**Re: Christina Lake Thermal Project Phase H and Eastern Expansion
Round 3 Supplemental Information Request Responses
AER Application No. 1758947
EPEA Application No. 019-48522**

Cenovus FCCL Ltd. (Cenovus), as operator for FCCL Partnership, submitted the Christina Lake Thermal Project Phase H and Eastern Expansion Project Application to the Energy Resources Conservation Board (now the Alberta Energy Regulator [AER]) and Alberta Environment and Sustainable Resource Development (ESRD) on March 22, 2013. Following this submission, the AER and ESRD issued the Round 1 and Round 2 Supplemental Information Requests (SIRs) on February 24, 2014 and November 21, 2014, respectively. Cenovus provided responses to the Round 1 and Round 2 SIRs on June 23, 2014 and January 22, 2015. Further to this, the AER issued the Round 3 SIR on March 12, 2015. The enclosed document provides responses to the Round 3 SIR.

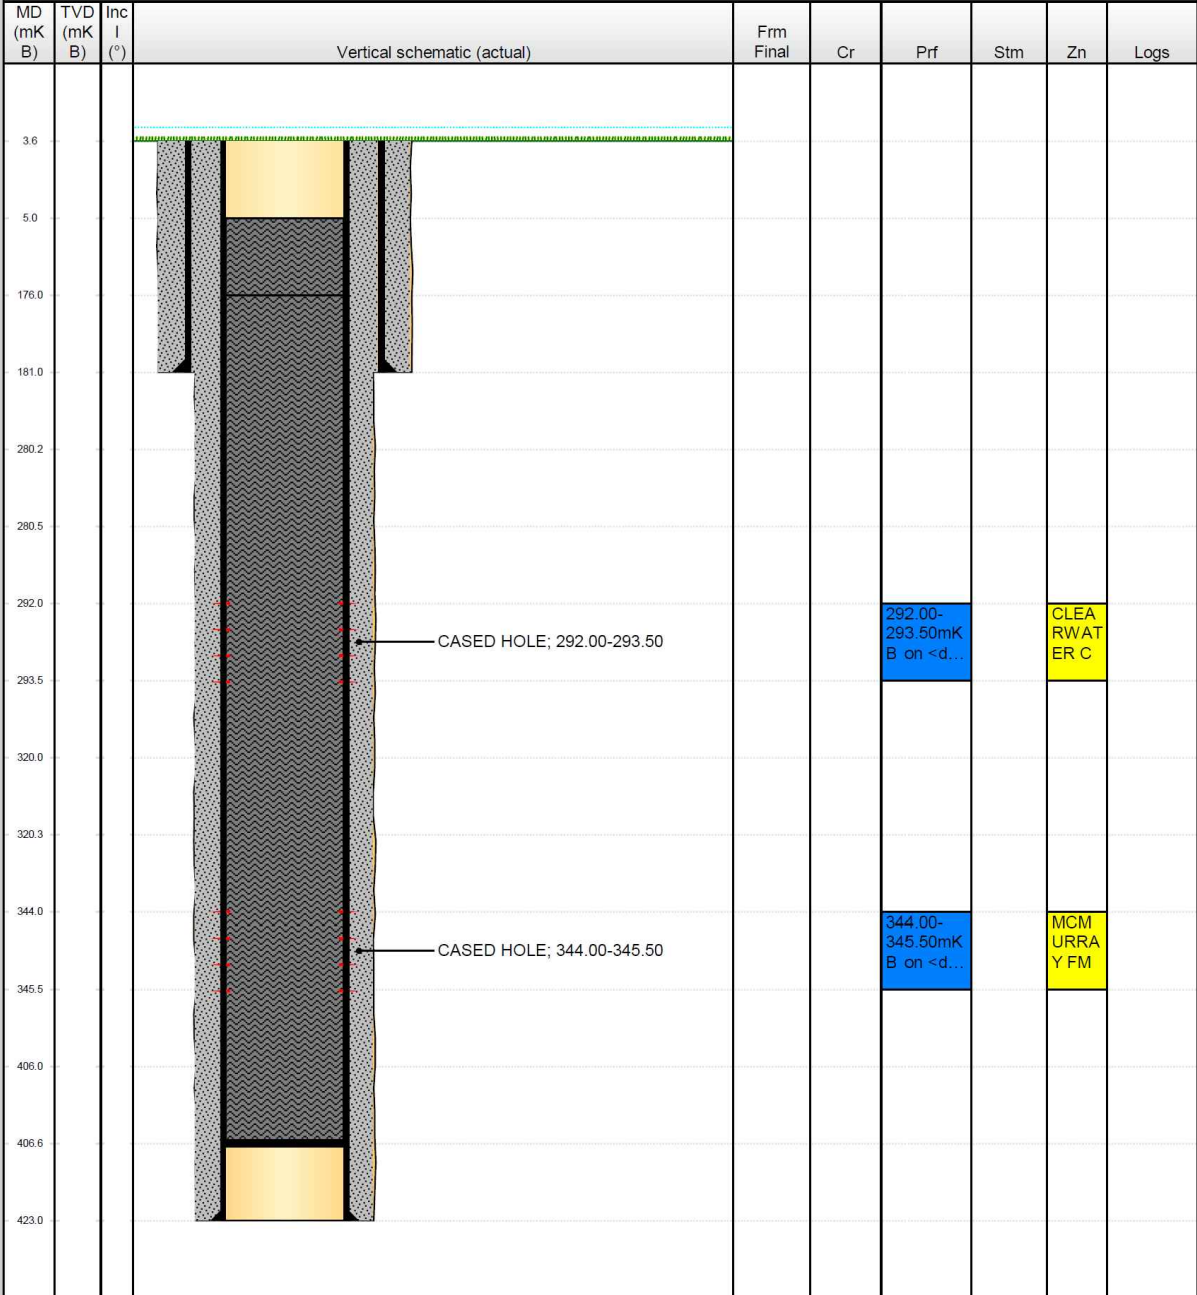
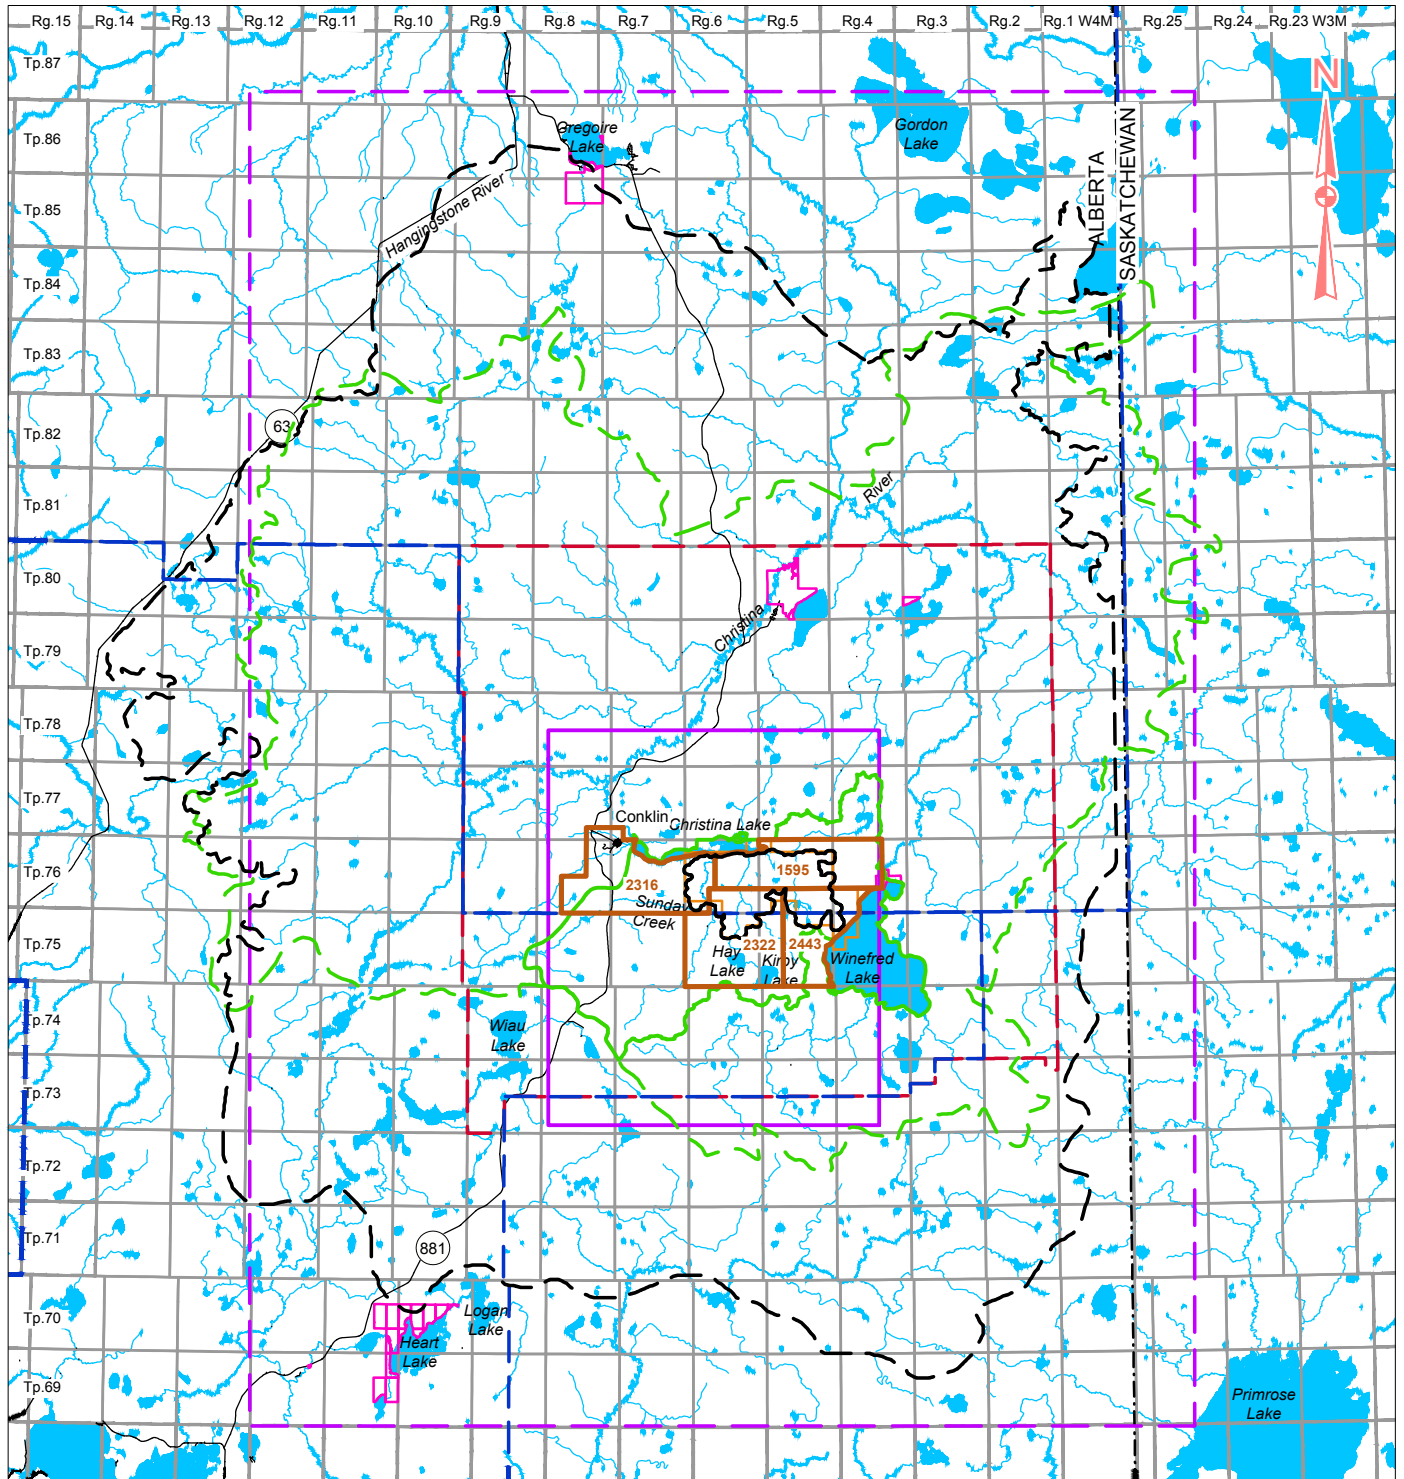
2. Section 6.7.1.2, Table 6.7-1: Thermal Compatibility Assessment Results Summary, Page 6-24. The following wells appear to be Directive 020 noncompliant. Provide formation tops to complete this evaluation and address the gaps in the cement plugs for the following wells:

UWI	Cement information
00/09-06-076-05W4	Cement gap 30-336 mKB
00/11-01-076-06W4	Bridge plug plus 8 m of cement at 282 mKB and 320 mKB
00/16-20-076-06W4	Bridge plug plus 8 m of cement at 240 mKB and 324 mKB
00/07-06-076-04W4	Bridge plug plus 3 m cement at 408 mKB, bridge plug plus 23 m cement at 397 mKB, and bridge plug plus 8 m cement at 363 mKB

Cenovus completed the remediation of well 00/11-01-076-06W4 in March 2015, as approved by the AER Well Operations on February 17, 2015 ([Table 2-1](#)). The well was re-entered and thermally abandoned by placing a cement plug from true depth (TD) into the surface casing, and covering the production casing and connections with Class G thermal cement. In addition, to confirm hydraulic isolation through the caprock interval the Clearwater perforations were squeezed off and drilled out. The updated well log for this well is provided in [Figure 2-1](#).

FIGURE:3-1

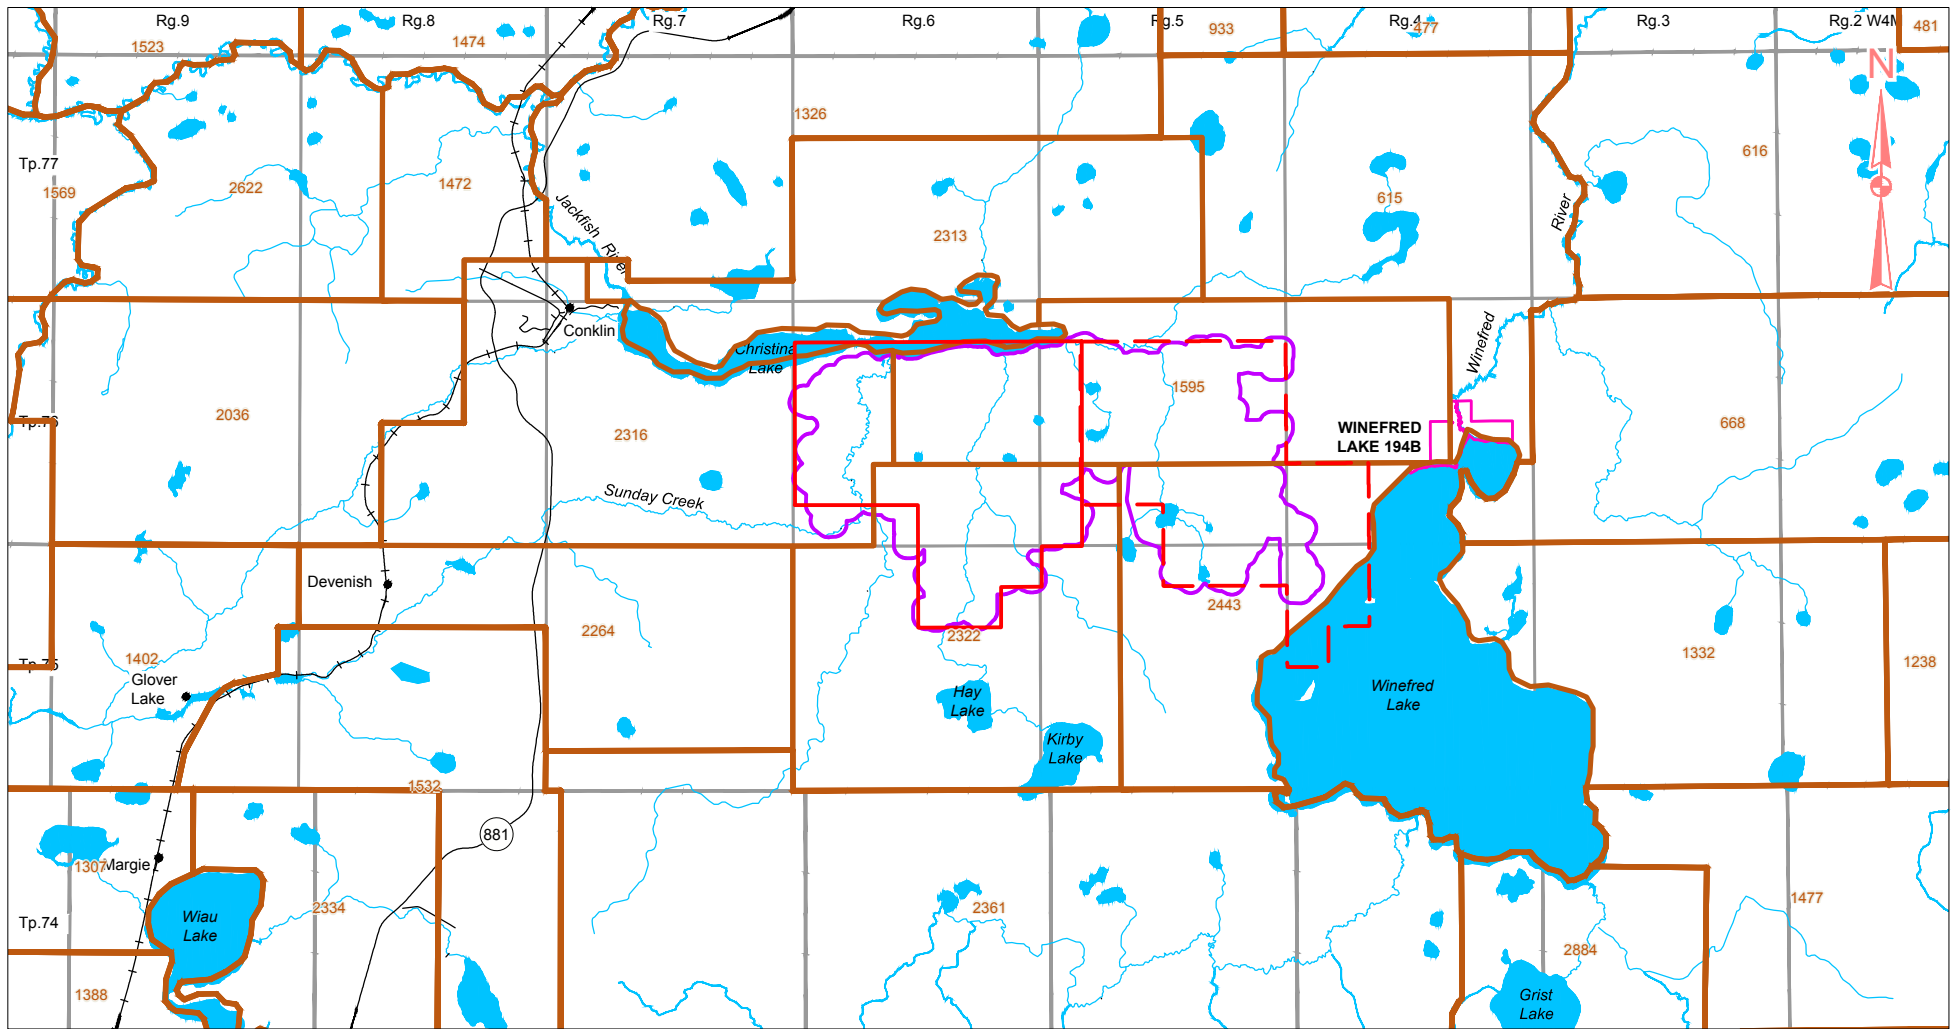
3. **Volume 2, Section 4.3.8.1, Page 4-25. Cenovus identifies that “the Traditional Land Use (TLU) LSA, Lease Area, and local Registered Fur Management Areas (RFMAs) are shown in Figure 4.3-1. The LSA partially overlaps RFMA #s 1595, 2316, 2322 and 2443. Of these, RFMA #2316 is registered to a Métis trapper and will be assessed in the TLU Assessment.”**
- a. **Local Registered Fur Management Areas (RFMAs) are NOT shown in Figure 4.3-1. Include all overlapping RFMAs in Figure 4.3-1;**
 - b. **To illustrate overlap of the project and the expansion with RFMAs, include the project area, and identify the Phase H area and eastward expansion in Figure 2.2-2;**
 - c. **Provide rationale for excluding RFMA #s 1595, 2316, 2322 and 2443 from the TLU assessment and provide updates on consultation activities with RFMA holders, if they have occurred.**

- a. [Figure 4.3-1](#) has been updated and provided as [Figure 3-1](#).
- b. [Figure 2.2-2](#) has been updated and provided as [Figure 3-2](#).
- c. The effects of the Project on Registered Fur Management Area (RFMA) #2316 were assessed in [Volume 6, Section 2.7](#) of the TLU Assessment because it is registered under an Aboriginal Trapper. RFMAs #1595 and #2322 are registered to a non-Aboriginal trapper; therefore, they were not included in the TLU assessment. The effects of the Project on RFMAs #1595 and #2322 were assessed in [Volume 6, Section 3.5.3](#) of the Resource Use Assessment. RFMA #2443 is registered to a Métis trapper. Although RFMA #2443 was inadvertently excluded from the TLU assessment, it was assessed in [Volume 6, Section 3.5.3](#) of the Resource Use Assessment.
